Leicestershire County Council: North and East Melton Mowbray Distributor Road (MMDR)

Stage 2 Road Safety Audit

Report Number: 60542201-ACM-LSI-GEN_GEN_ZZ_Z-RP-CH-0002

30th November 2020

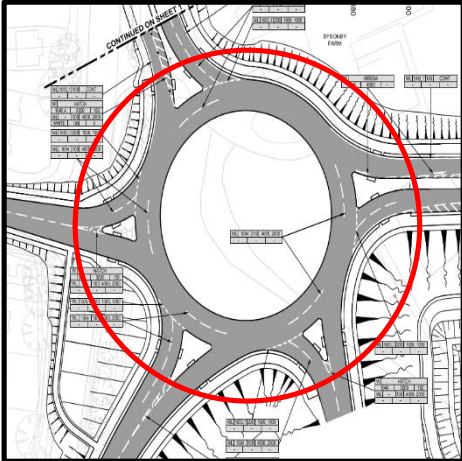
Problem 4.3.1	
Drawing Number(s):	Various
Location:	Various
Summary:	Width of running lanes at the proposed roundabouts may lead to vehicles not being able to safely and efficiently pass side-by-side resulting in graze-type collisions occurring.
Description:	
<p>Carriageway widths have been provided on the Cross Section drawings; however, no information has been provided to the Audit Team to outline the widths of the proposed running lanes at the roundabouts detailed throughout the extents of the scheme. If vehicles cannot safely and efficiently pass side-by-side through the proposed roundabouts, they may overhang the centre line leading to potential graze-type collisions or travel too close to the edge of the carriageway and strike the kerbs resulting in loss of control collisions. Of particular concern are vehicles with a larger turning circle such as buses or refuge vehicles.</p>	
Recommendation:

It is recommended that that all running lanes are of adequate width are provided to allow all vehicles types to proceed without overhanging lanes.	
RSA 2 Designer's Response	
<p>Swept path analysis has been undertaken confirming that all vehicles including maximum legal HGVs can negotiate the roundabout. Up to a maximum legal HGV and 7.5t HGV can negotiate the roundabout side by side. Increasing the ICD's further to accommodate two max legal HGV's side by side would lead to poor deflection and the appearance of reverse curves as well as increased costs and land take. As permitted by the standards, partial concentric lane markings are shown within the roundabout circulatory to provide guidance for smaller vehicles without fully delineating a two lane circulatory.</p>

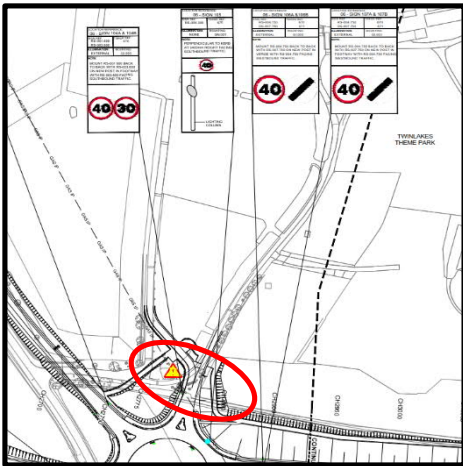
Problem 4.3.2	
Drawing Number(s):	Various.
Location:	All roundabouts within the scheme extents.
Summary:	Unclear number of lanes at the exit to the circulatory leading to side swipe or graze-type collisions.
Description:

<p>All approaches to the roundabouts have been detailed with two lanes; however, it is unclear whether the exits to the circulatory are one or two lanes. The exits to the circulatory appear wide which may lead to drivers exiting the circulatory from two lanes resulting in side swipe or graze-type collisions occurring.</p>	
Recommendation:	
<p>It is recommended that the exits are clearly marked for one or two lanes. If an exit is two lanes an appropriate merge taper should be provided.</p>	
RSA 2 Designer's Response	
<p>The design standards require the exit from the roundabouts to be greater than 6m wide in order to allow space for motorists to pass broken down vehicles. The width shown allows for limited merge manoeuvres and following discussions with road safety specialists the design decision was made to show only merge arrows, rather than fully marking as two separate lanes.</p>

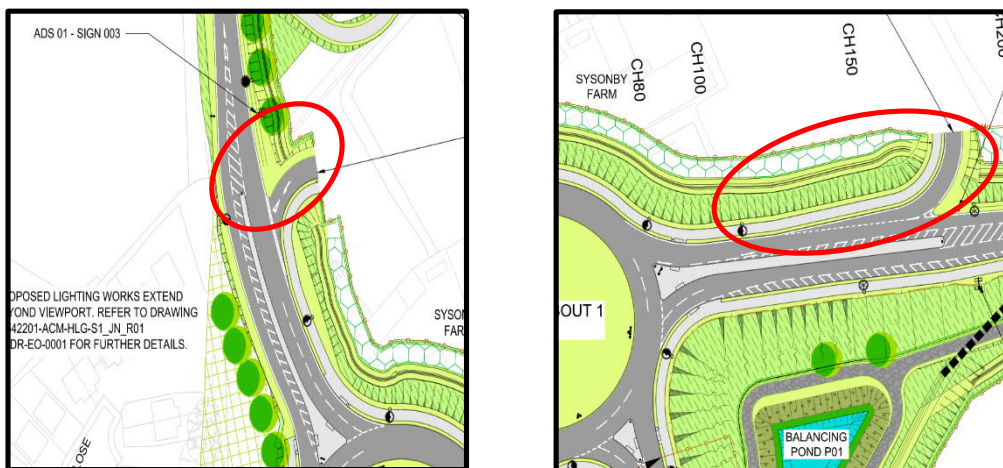
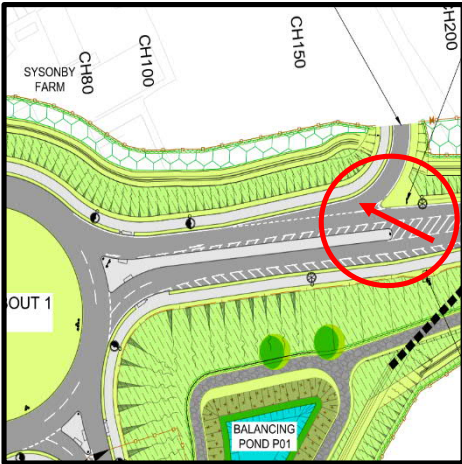
Problem 4.3.4	
Drawing Number(s):	60542201-ACM-GEN-S1_ML_ZZ_Z DR-Z-0001 P01
Location:	Access and exit roads for the development site.
Summary:	Drivers inadvertently turning into the development site road leading to unsafe manoeuvres and collisions with other road users.
Description:

An access and exit point for a development site has been detailed in the vicinity of Roundabout 1. It is unclear whether access to the development will be permitted once the MMDR is constructed; no measures have been detailed which indicate that users cannot access the development site. There is a risk that if access isn't permitted, drivers may inadvertently turn onto the diverge road, for the development site, and become hesitant or confused, potentially leading to a driver undertaking unsafe turn manoeuvres and collisions occurring with other road users.

Recommendation:
It is recommended that physical measures are installed to prevent vehicles using the access and exit points to the development site until the development site is complete.

RSA 2 Designer's Response
Appropriate signage and physical measures will be installed as temporary traffic management measures to prevent the inadvertent use of the access and exit points to the development site by unauthorised vehicles prior to its completion.

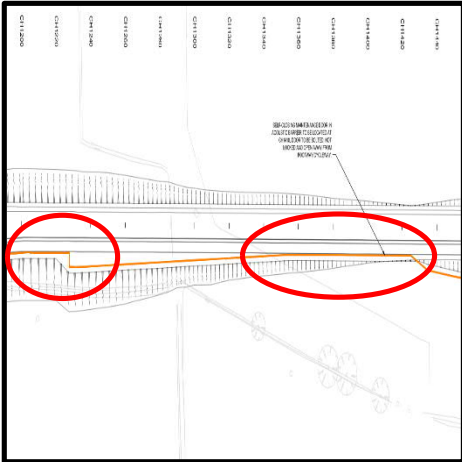
Problem 4.3.5	
Drawing Number(s):	60542201-ACM-GEN-S1_ML_ZZ_Z DR-Z-0001 P01
Location:	Access road for the development site.
Summary:	Drivers undertaking a right turn movement into the development site resulting in loss of control or side swipe collisions.
Description:

<p>A kerbed central median has been detailed on the MMDR, east of Roundabout 1. It appears that this has been provided to prevent drivers from turning right from the MMDR into the development site; however, the kerbed central median does not extend far enough east, past the development access, to prevent drivers from attempting to make the right turn manoeuvre. Although unlikely, if drivers attempt to turn right from the westbound MMDR carriageway into the development site they may undertake sharp turn movements leading to loss of control collisions or turn across an oncoming vehicle leading to a side swipe collision.</p>	
Recommendation:	
<p>It is recommended that the kerbed central median is extended to prevent drivers turning right from the MMDR into the development access.</p>	
RSA 2 Designer's Response	
<p>The proposed kerbed central median currently extends beyond the junction nosing for the slip road into the development. Any vehicles undertaking a right-turn manoeuvre from the westbound carriageway in this location would be forced to travel for several metres in a westbound direction on the eastbound carriageway and on the wrong side of the central reserve. This is deemed to be sufficient to discourage vehicles from undertaking this illegal right-turn manoeuvre from the MMDR westbound carriageway.</p>

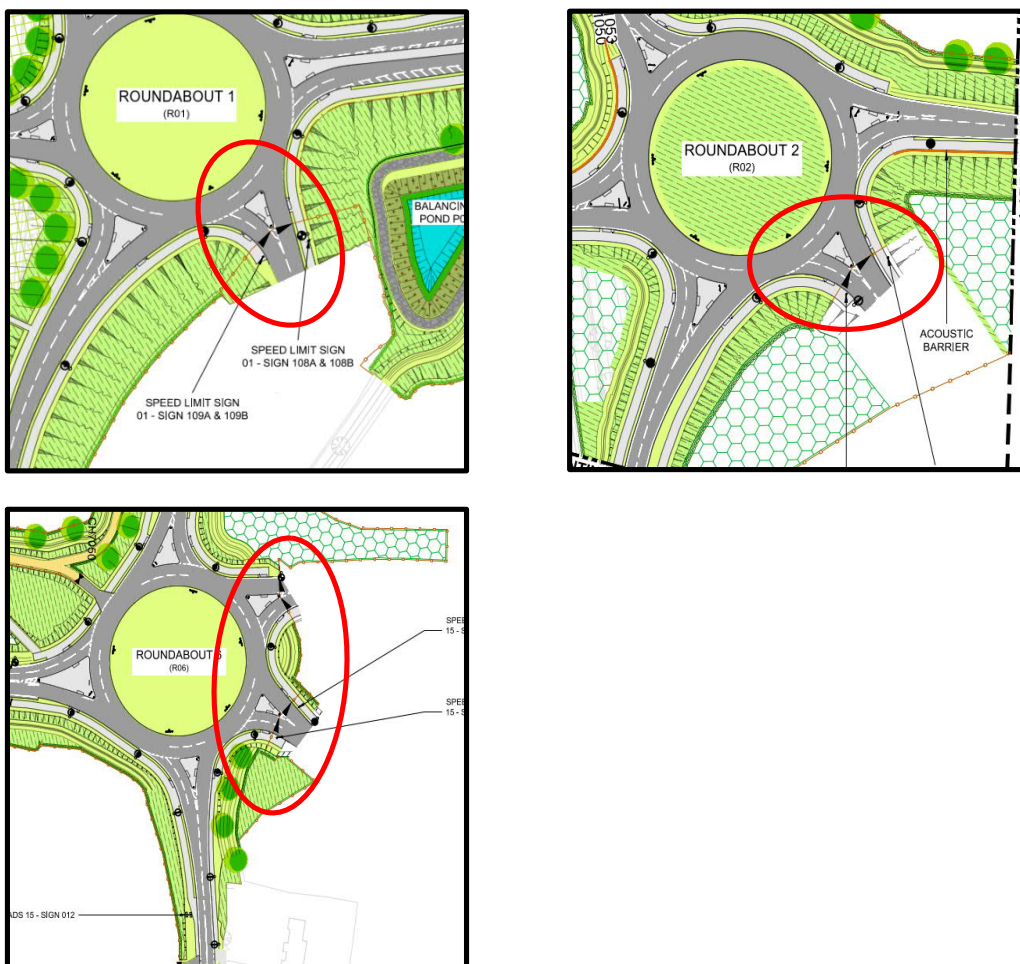
Problem 4.3.7	
Drawing Number(s):	Various.
Location:	Various.
Summary:	Unused roundabout arms leading to unsafe manoeuvres and conflicts and collisions occurring with circulating vehicles.
Description:

Roundabouts 1, 2 and 6 have additional arms which appear to be unused and undeveloped at this stage of the scheme. If drivers are not aware that these arms are not to be used, they may become confused and hesitate on the approach to these exits, mistaking them for the signed exits. Unsafe manoeuvres may be carried out leading to conflicts and collisions with circulating vehicles. Alternatively, driver hesitations may lead to shunt-type collisions.

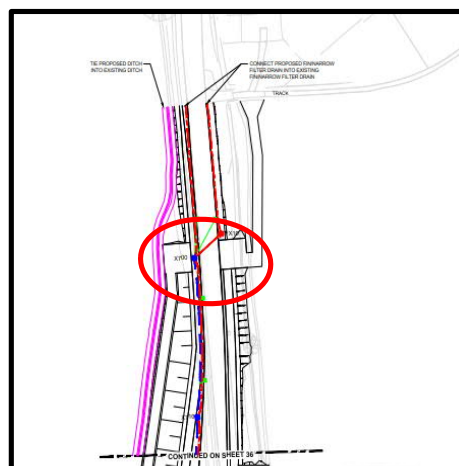
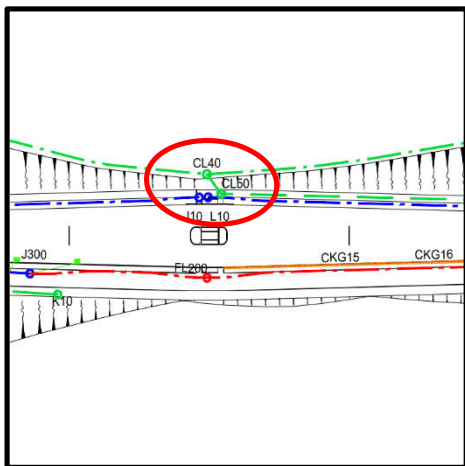
Problem 4.8.1	
Drawing Number(s):	60542201 ACM HDG S2_ML_M02_Z DR CD 0013 P03 and 60542201 ACM HDG S5_JN_R06_Z DR CD 0035 P03
Location:	Proposed pedestrian crossing at approximate chainage CH2525 and proposed Pegasus crossing south of Roundabout 6.
Summary:	Drainage provisions within crossing points leading to pedestrian and equestrian slips, trips and falls resulting in injuries.
Description:

A number of drainage provisions have been detailed at the proposed pedestrian crossing to the west of Roundabout 3 and the Pegasus crossing to the south of Roundabout 6. There is a risk

that if manhole covers are positioned at the crossing points, pedestrians or equestrians may step on to them leading to slips, trips and falls occurring or a rider becoming unmounted from their horse resulting in injuries. This issue will be exacerbated during periods of inclement weather.

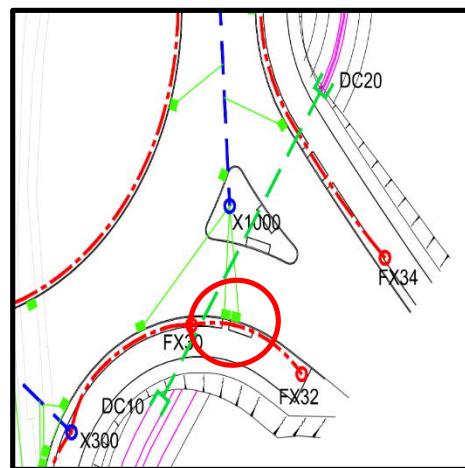
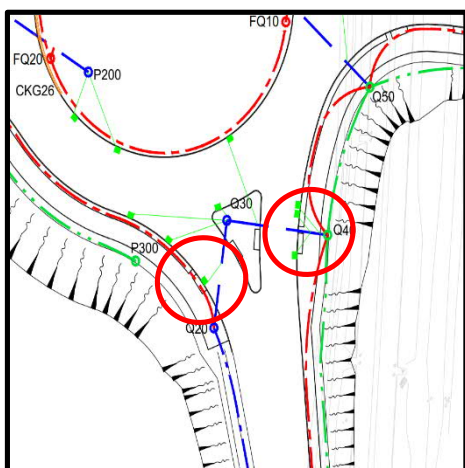
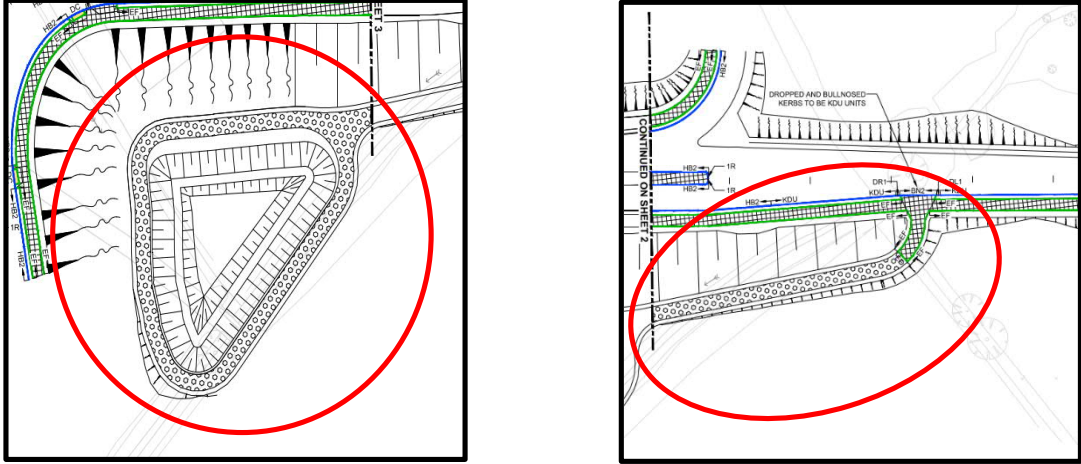
Drawing Number(s):	Various.
Location:	Various crossing points located throughout the scheme extents.
Summary:	Potential trips and falls due to poorly located gullies.
Description:

There are several locations throughout the scheme extents where proposed gullies are positioned within pedestrian crossing points (examples shown above). If gullies are provided at the dropped crossings, within pedestrian desire lines, the likelihood of pedestrian trips and falls occurring will be heightened.

Proposed gullies will be positioned away from all dropped crossing points.

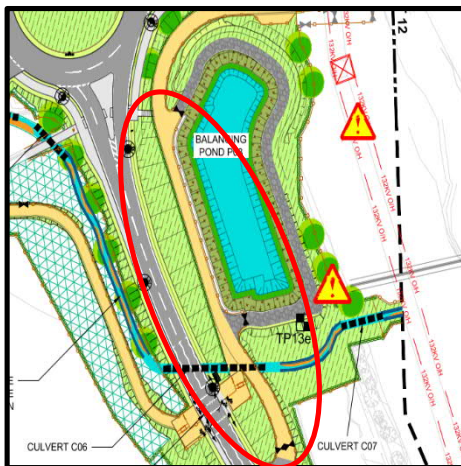
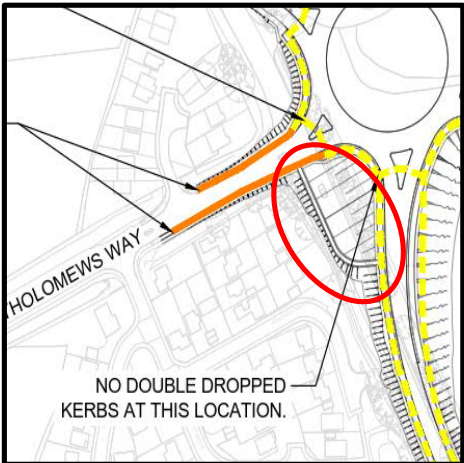
Problem 4.9.2	
Drawing Number(s):	60542201-ACM-GEN-S4_ML_ZZ_Z-DR-Z-0011 P01.
Location:	Access track to balancing pond P08.
Summary:	Surface course may lead to drivers losing control and colliding with NMUs resulting in injuries.
Description:

Maintenance vehicles are to access balancing pond P08 via a proposed bridleway, with bridleway surfacing detailed. There is a risk that maintenance vehicles may not have sufficient grip as they travel over the bridleway surface course which may lead to them being unable to stop efficiently resulting in conflicts and collisions with NMUs and potential injuries occurring.

It is recommended that a bound surface material is used throughout the bridleway section which can also be used by vehicular traffic to access the pond.

Vehicular access by maintenance vehicles is very occasional. Vehicle speeds are expected to be very low and the risk of skidding is considered to be very low. In addition, installation of a bound surface material is not considered appropriate for this location due to it being an equestrian route.

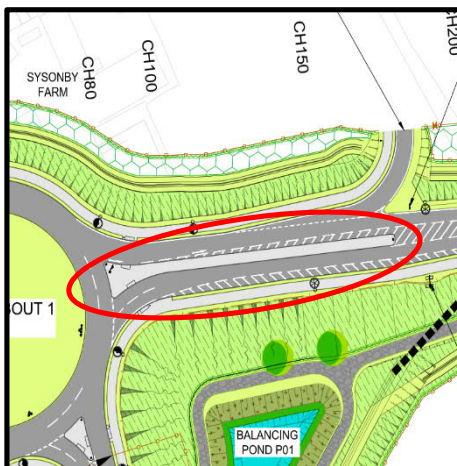
Problem 4.11.2	
Drawing Number(s):	60542201-ACM-GEN-S1_ML_ZZ_Z-DR-0001 P01
Location:	MMDR kerbed central median in the vicinity of the development site.
Summary:	Pedestrians may cross away from the designated crossing point leading to trips and falls or potential conflicts and collisions with vehicular traffic resulting in injuries.
Description:

As part of the design, a kerbed central median has been provided on the MMDR, east of Roundabout 1. The length of the kerbed central median extends past the entry to the development site and also prevents vehicles turning right from the MMDR into the development site. There are concerns that pedestrians may attempt to cross the MMDR in 2 phases, using the kerbed central median as a refuge area. If pedestrians attempt to cross away from the designated crossing point, trips and falls may occur as they traverse a full height kerb or conflicts and collisions may occur with vehicular traffic who may inadvertently strike a pedestrian resulting in injuries.

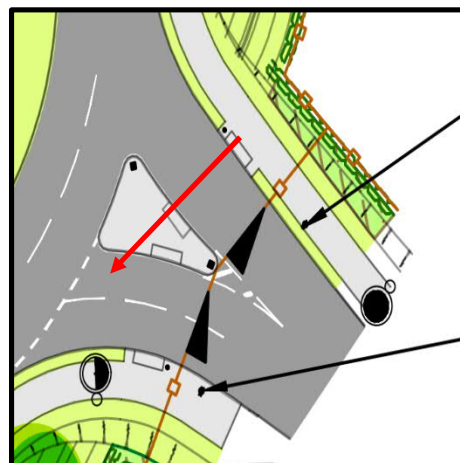
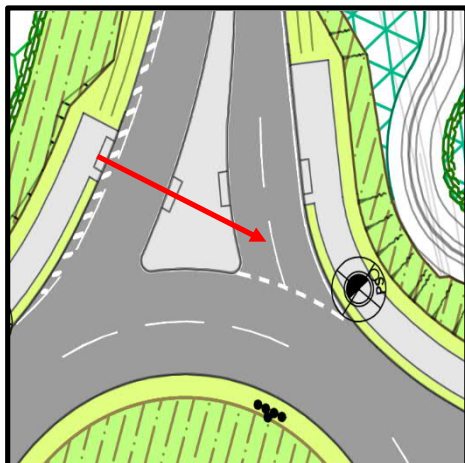
Problem 4.11.5	
Drawing Number(s):	Various.
Location:	Various.
Summary:	Inadequate alignment of tactile paving slabs may result in pedestrian injuries
Description:

Uncontrolled pedestrian crossing points are proposed across all roundabouts throughout the scheme, however, the tactile paving slabs within a number of the central splitter islands are poorly aligned (examples are shown above). The alignment is such that partially sighted pedestrians may not be able to locate the second set of tactile leading to them to inadvertently cross at unsafe locations, resulting in trips and falls should they traverse a full height kerb.

The uncontrolled crossing points and associated tactile paving have been aligned so that they are close to right-angles to the traffic lane which is being crossed and where possible are located away from the final carriageway flare. This ensures all pedestrians are exposed to live traffic for the shortest distance possible and gives sighted pedestrians good visibility of approaching traffic. The tactiles either side of the carriageway are aligned with each other but due to the angles of the splitter island it has not always been possible to fully align the tactiles within splitter islands. However, the alignment of the tactiles within splitter islands will be reviewed and amended where required to ensure that the most appropriate location and alignment is achieved.

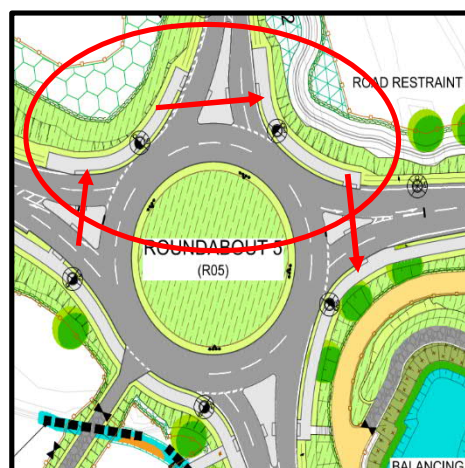
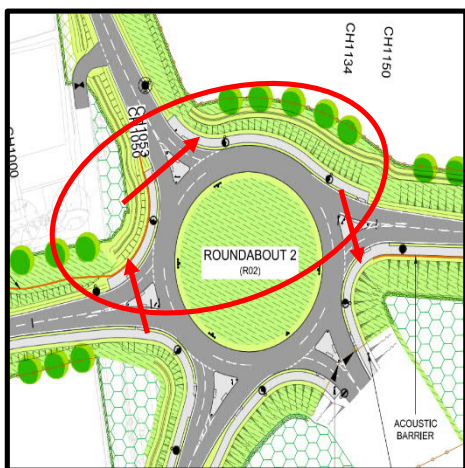
Problem 4.11.6	
Drawing Number(s):	Various.
Location:	Various.
Summary:	NMU provisions heightening the risk of pedestrian conflicts and collisions with vehicular traffic resulting in injuries.
Description:

It appears that sections of footway/cycleways have been detailed around a number of the roundabouts (examples shown above), which may lead to pedestrians crossing additional carriageways to continue their journeys. These sections of footway/cycleway appear to be installed for cyclists travelling through the roundabouts with no deterrent for pedestrian usage. If pedestrians cross a number of carriageways to continue their journeys, instead of taking the shortest route through the roundabouts, the risk of them being struck by vehicles may be increased resulting in injuries.

Pedestrians have good visibility across the roundabouts and will naturally choose the shortest route available to them for their journey. Additional signage is unnecessary and would only add to sign clutter.

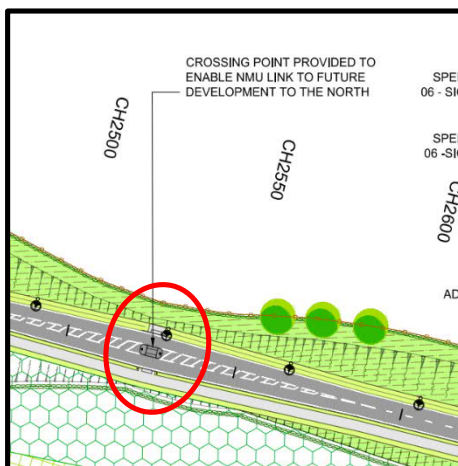
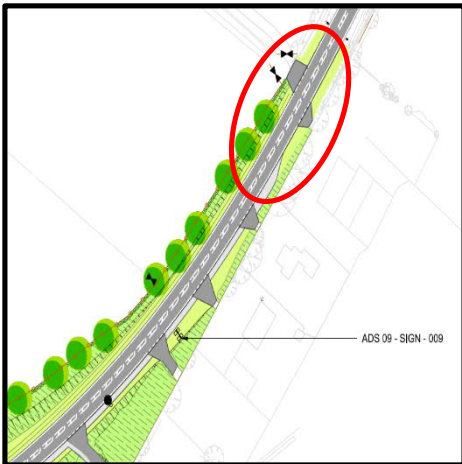
Problem 4.11.7	
Drawing Number(s):	60542201-ACM-GEN-S2_ML_ZZ_Z-DR-Z-0006 P01.
Location:	Proposed NMU crossing; west of Roundabout 3.
Summary:	NMU provision may heighten the risk of conflicts and collisions with vehicular traffic resulting in injuries.
Description:

An NMU crossing point has been detailed, to the west of Roundabout 3, to cater for NMU access/egress to a future development. There is a risk that if the crossing point is installed prior to the future development being completed, NMUs may use the crossing and continue their journey within an uneven verge leading to potential trips and falls or attempt to cross the MMDR again increasing the risk of being struck by an oncoming vehicle resulting in injuries.

It is recommended that measures are incorporated to prevent NMUs using the crossing point until the future development is completed.

Until the future development is in place, there will be no pedestrian desire line in this location and pedestrians will be able to see that the crossing does not lead to the development without crossing the road. For this reason the risk of pedestrians choosing to cross in this location is very low and measures to prevent NMUs using the crossing point would not provide any safety benefit.

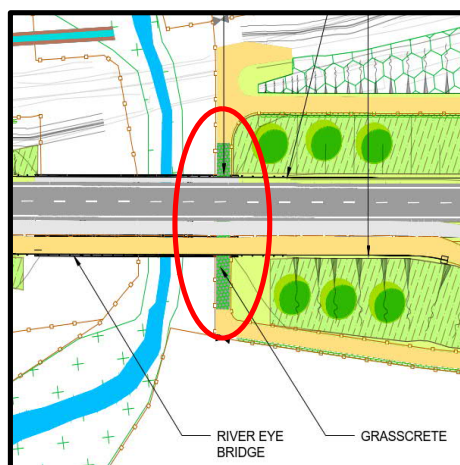
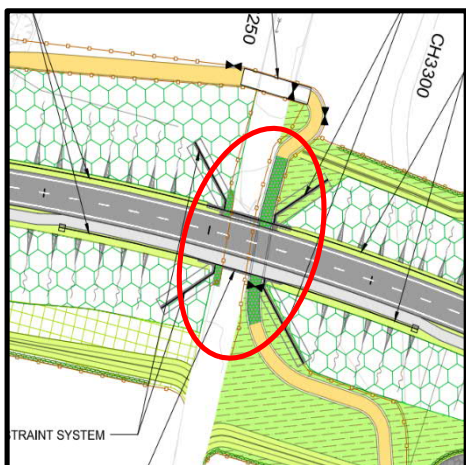
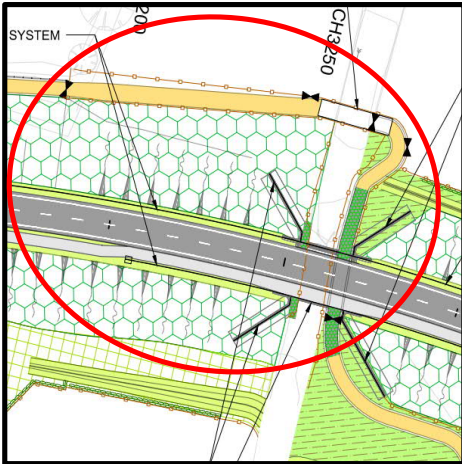
Problem 4.12.2	
Drawing Number(s):	60542201-ACM-GEN-S3_ML_ZZ_Z DR Z 0008 P01 and 60542201-ACM-GEN-S5_ML_ZZ_Z DR Z 0012 P01
Location:	Bridleway's at Thorpe Brook and River Eye Bridge
Summary:	Surfacing detailed may lead to horses having trouble travelling along the proposed route, resulting in riders potentially being unmounted and injuries occurring.
Description:

Grasscrete has been detailed at the Bridleway's under the Thorpe Brook and River Eye Bridges. There is a risk that horses may get their hooves trapped within the Grasscrete or the Grasscrete will lead horses to stumble as they travel over it potentially causing them to fall or unmount their rider resulting in injuries.

It is recommended that an adequate surface course is provided for horses and their riders at all bridleways throughout the scheme extents.

The 'grasscrete' solution proposed will be reviewed to ensure that the most appropriate product is selected which will balance the needs of horses and riders as well as providing a durable surface for potentially wet conditions next to Thorpe Brook and the River Eye bridges.

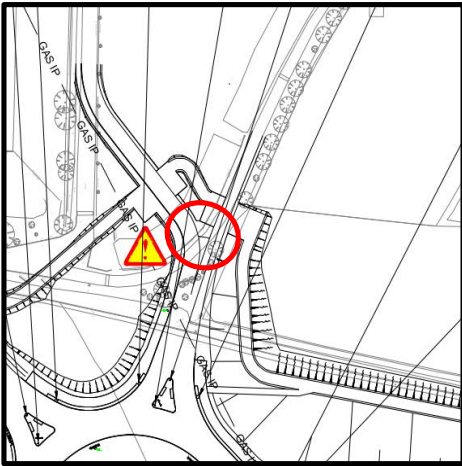
Problem 4.13.2	
Drawing Number(s):	Various
Location:	Various locations throughout the scheme extents.
Summary:	Increase in collision severity due to incorrect signposts being installed.
Description:	
<p>No signpost diameter details have been provided to the Audit Team at this Stage 2 Road Safety Audit. There are concerns that if signposts that are too large are installed and an errant vehicle were to leave the carriageway and strike the signposts the severity of the collision could be increased.</p>	
Recommendation:	
It is recommended that all traffic signs are installed on passive safe signposts or are protected by a RRS where there is a risk of collision.

All traffic signs proposed have been designed on passively safe signposts.
